Contract #: 04-0120F4Cty: SF/ALA Rte: 80 PM: 13.2/13.9File #: 69.25B**QUALITY ASSURANCE -- NON-CONFORMANCE REPORT****Location:** Changxing Island, Shanghai, China**Report No:** NCR-000954**Prime Contractor:** American Bridge/Fluor Enterprises, a JV**Date:** 24-Dec-2010**Submitting Contractor:** Zhenhua Port Machinery Company, Ltd (ZPMC), Changxing Island**NCR #:** ZPMC-0913**Type of problem:**

Reference Description: Base Metal Repair without Prior Approval from the Engineer**Description of Non-Conformance:**

Job Name: SAS Superstructure
Document No: 05.03.06-000910

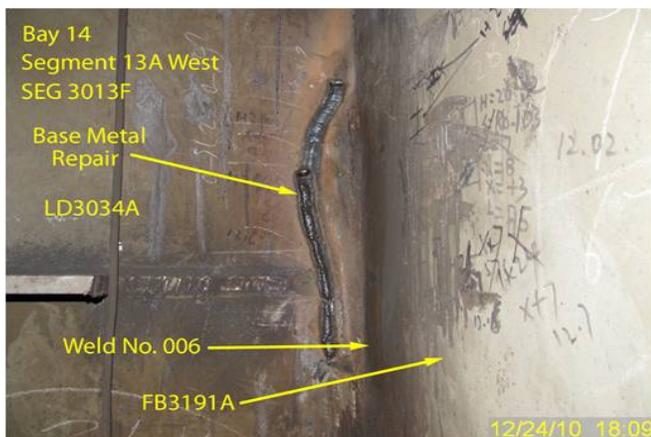
-ZPMC personnel performing base metal repair on the Longitudinal Diaphragm (LD) web at W3, panel point 119 +1500 of Segment 13AW without the Engineer's approval.

-The Longitudinal Diaphragm is identified as: LD3034A

- Repairs were being performed adjacent to the Vertical web splice identified as LD3034-003 and floor beam to LD weld identified as SEG3013F-006.

Standard Specifications (99) section 8-3.01: "The Engineer shall be notified immediately in writing when welding problems, deficiencies, base metal repairs, or any other type of repairs not submitted in the WQCP are

ZPMC Welding Quality Control Plan, Section 9.2.1.2: “Prior approval of the Engineer shall be obtained for repairs to base metal other than what was identified in Section 9.2.1.1 of this manual and the repair of all other cracks.”

AWS D1.5/2002, Section 3.7.4: “Prior approval of the Engineer shall be obtained for repairs to base metal.”

ZPMC is providing NDT of the base metal repair to show that the repair was successful. The QA and QC departments have been reminded that if they see repairs they must verify that the proper documents on hand before allowing the repair to proceed. The production foreman has been reminded as well that documents on hand are needed before this work should be executed. Based on this ZPMC requests closure of this NCR.

This proposed resolution is acceptable. The documentation received is sufficient and the Department concurs that Non-Conformance ZPMC-0913 is closed.

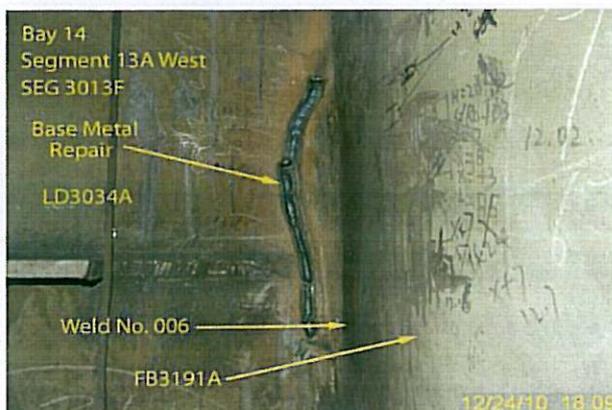
-ZPMC personnel performing base metal repair on the Longitudinal Diaphragm (LD) web at W3, panel point 119 +1500 of Segment 13AW without the Engineer's approval.

-The Longitudinal Diaphragm is identified as: LD3034A

-Repairs were being performed adjacent to the Vertical web splice identified as LD3034-003 and floor beam to LD weld identified as SEG3013F-006.

Contractor will provide the NDT report to prove the repair is successful. Contractor will remind the QC department and the production foreman that proper repair documentation should be on hand prior to any repair works.

Contractor provided the NDT report showing the repair is successful. The QC department and the production foreman was reminded that proper repair documentation should be on hand prior to execution of repair works.
